[Docket No. FAA-2009-1253; Directorate Identifier 2009-NM-080-AD; Amendment 39-16629; AD 2011-06-05]

Airworthiness Directives; The Boeing Company Model 737-600, -700, -700C, -800, -900, and -900ER Series Airplanes

ACTION: Final rule.

Figure 1

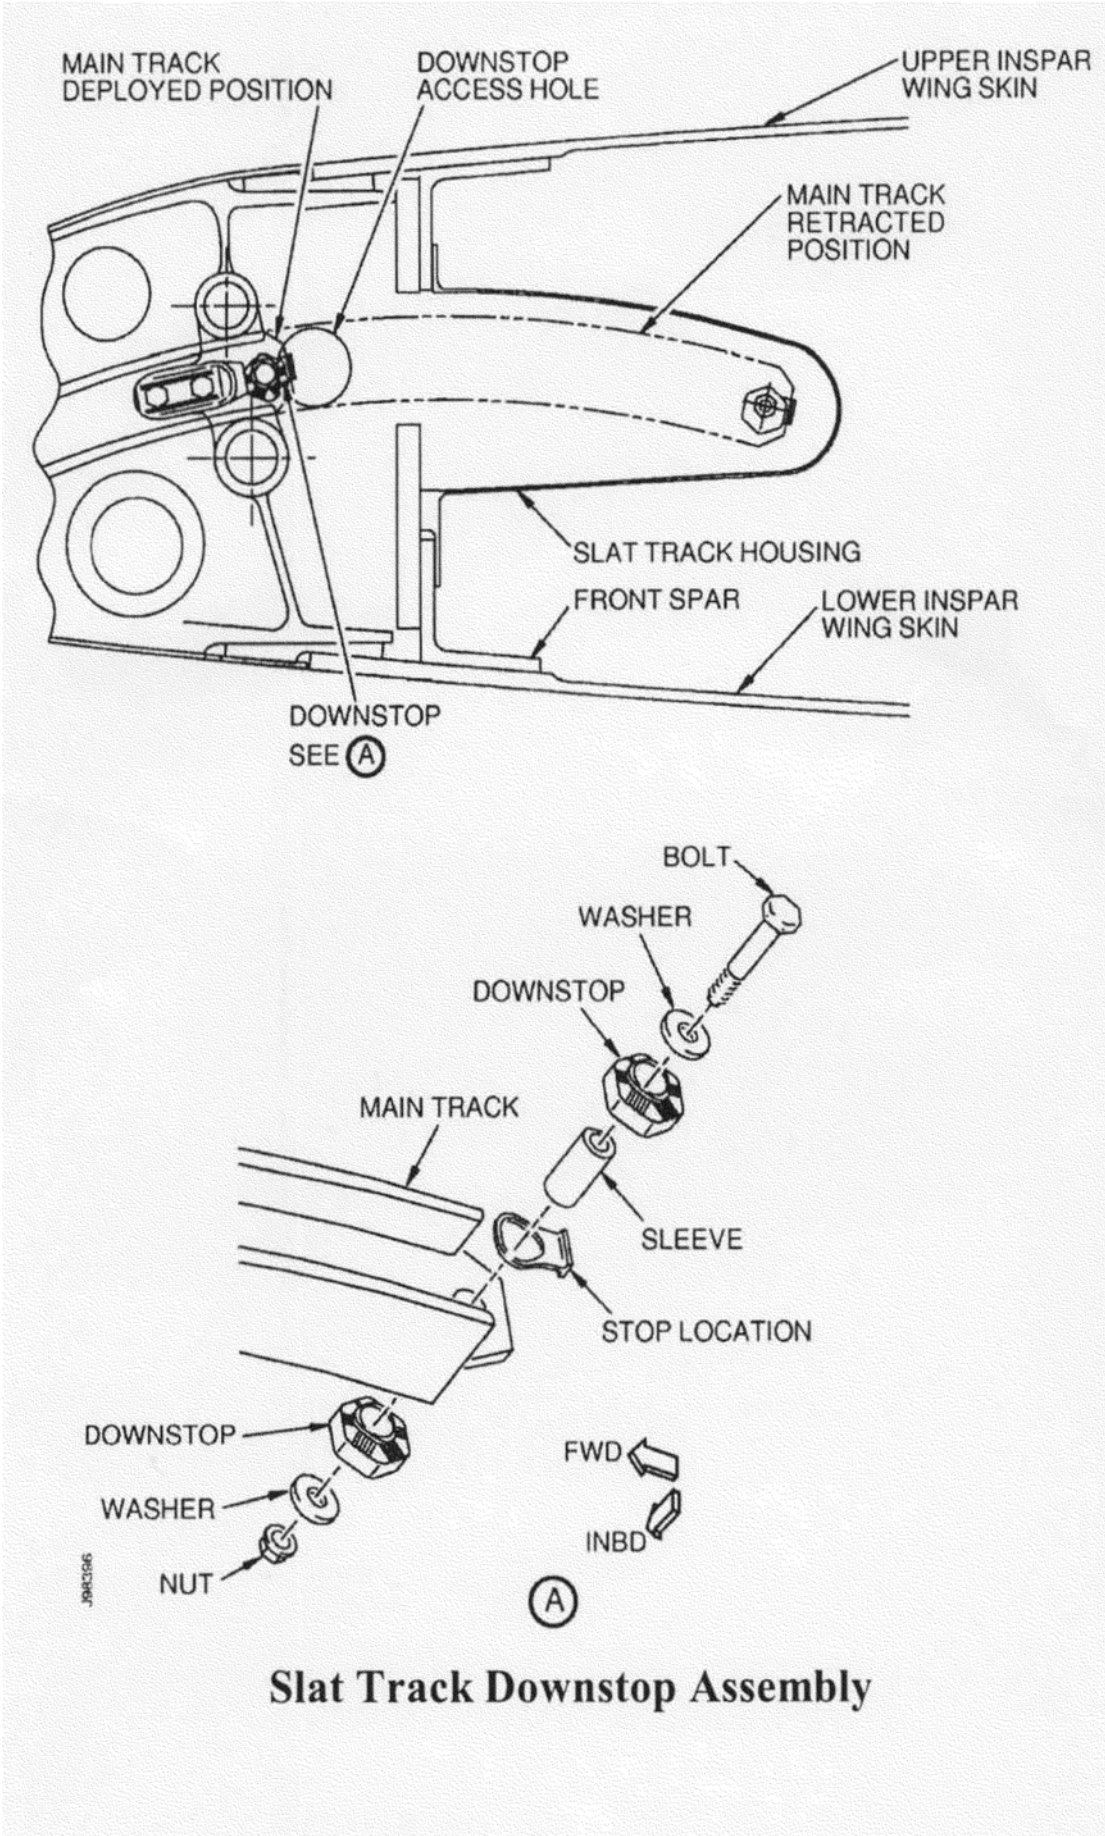
(g) Within 10 days after September 26, 2007 (the effective date of AD 2007-18-52): Do a detailed inspection or a borescope inspection of each main slat track downstop assembly to verify

proper installation of the slat track hardware (i.e., the bolt, washers, downstops, stop location, and nut shown in Figure 1 of Boeing Service Letter 737-SL-57-084-B, dated July 10, 2007, and in this AD). Proper installation of the sleeve need not be confirmed, and the stop location part may be installed on either the inboard or the outboard side of the slat track. If any part is missing or is installed improperly, before further flight, install a new or serviceable part using a method approved in accordance with the procedures specified in paragraph (j) of this AD; and do a detailed inspection of the inside of the slat can for foreign object debris (FOD) and damage. Before further flight, remove any FOD found and repair any damage found using a method approved in accordance with the procedures specified in paragraph (j) of this AD. Verify proper installation; install a new or serviceable part; and inspect for damage and FOD, and remove FOD and repair damage; in accordance with a method by approved by the Manager, Seattle Aircraft Certification Office, FAA; or in accordance with Boeing Multi Operator Message Number 1-523812011-1, issued August 25, 2007, or 1-527463441-1, issued August 28, 2007. Repeat the actions required by paragraph (g) of this AD thereafter at intervals not to exceed 3,000 flight cycles.

(h) Within 24 days after receipt of emergency AD 2007-18-51: Apply a torque between 50 to 80 inch-pounds to the nut. The bolt head must be held with the torque applied to the nut.
